Approval of Reserved Matters Consultation

Application Number: 253071

Site Address: Land To West Of Park Lane, Charvil, RG10 9TS

MEMORANDUM

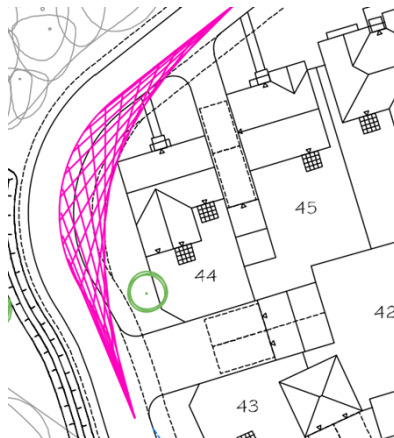
2. Any amended drawings submitted should display the proposed carriageway dimensions and corner radii across the site layout. The drawings should include a scale bar.
3. The LHA require submission of a drawing which demonstrates suitable visibility around all bends on site. Forward visibility only appears to be demonstrated outside plot 44.
4. The LHA require amendment of the building line outside Plot 44. The sightline passes very close to the building and if OS mapping is inaccurate or the building footprint varies slightly there will not be suitable forward visibility. The LHA also request that the footway outside Plot 44 is widened to allow the forward visibility displayed. This is to ensure the land will not be private and include obstructions to visibility in future such as fences or trees/hedges planted in future.

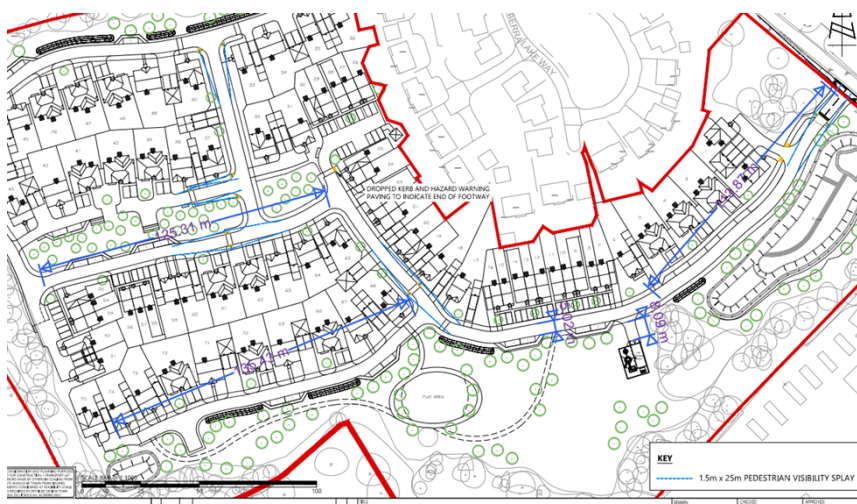
5. The LHA require the provision of traffic calming features within the site. The Wokingham Living Streets Guide (2019) requires a 20mph design speed on roads within new developments. The street design should naturally convey a 20mph speed. The LHA require traffic calming features on the two spine roads which splay east and west on the site layout plan. These spine roads are c.120m - 150m long roads which are almost straight. There is concern residents and delivery drivers will exceed the 20mph design speed unless

vertical or horizontal features are introduced which will result in traffic calming.

6. Tabled crossings would be welcomed in locations where crossings are needed. An additional uncontrolled crossing should be provided to the play area where a path is shown between the visitor parking spaces:

7. DfT LTN1/07 *Traffic Calming* advises that 'Speed control measures should be spaced at about 60 to 70 metres apart but not more than 50 metres from any given point unless on cul-de sacs less than 80 metres long...this spacing of traffic calming measures should ensure that the zone is self-enforcing (i.e. vehicle speeds are kept at least at or below an average of 20mph' (Paragraph 3.2.17). A screenshot is provided below highlighting the longer street sections which require speed reduction features:

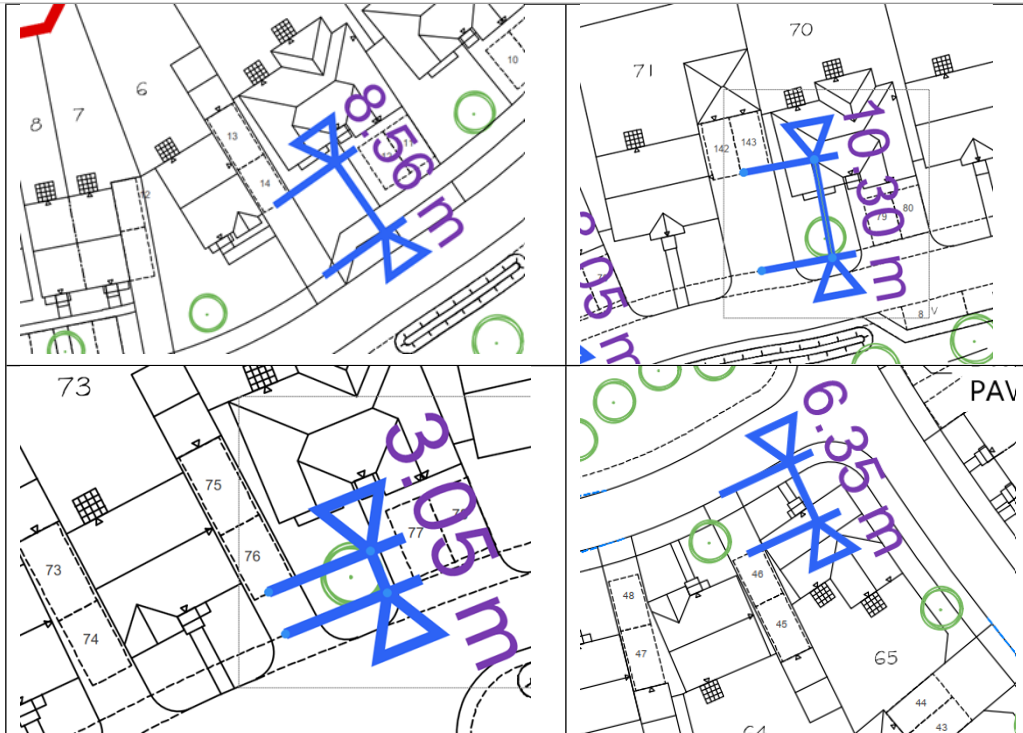
16. The LHA require parking spaces (and garage) outside numerous plots to be pulled further forwards closer to the carriageway. This includes Plot 6, Plot 7, Plot 42, Plot 43, Plot 44, Plot 49, Plot 64, 65, Plot 66, Plot 67, Plot 69, Plot 71, Plot 73 and Plot 74.
17. These dwellings appear to have excess driveway space between their parking spaces and the proposed carriageway; which could result in residents attempting to squeeze in additional parked cars and could result in parked cars overhanging the footway.
18. Otherwise, there is space in front of spaces which could result in use as informal parking spaces (but may not be large enough for a car) and this could result in vehicles overhanging the footway and encourage higher levels of car ownership/parking.
19. Some examples are provided below:

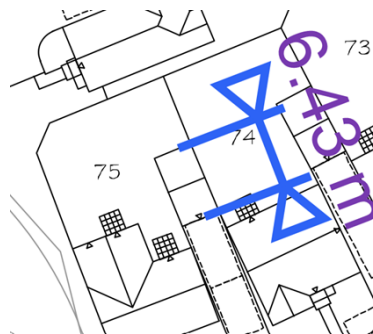
21. The LHA require amendment of the site plan to display the sheds which will be used for cycle storage. Some dwellings are displayed without a bike shed or a garage provided.
22. Garages should be enlarged to 7m x 3m. The garages appear 6.5m x 3m on the site plan which does not meet the WBC dimensions required for a garage to be considered large enough for car parking and cycle parking (WBC Parking Study 2011).
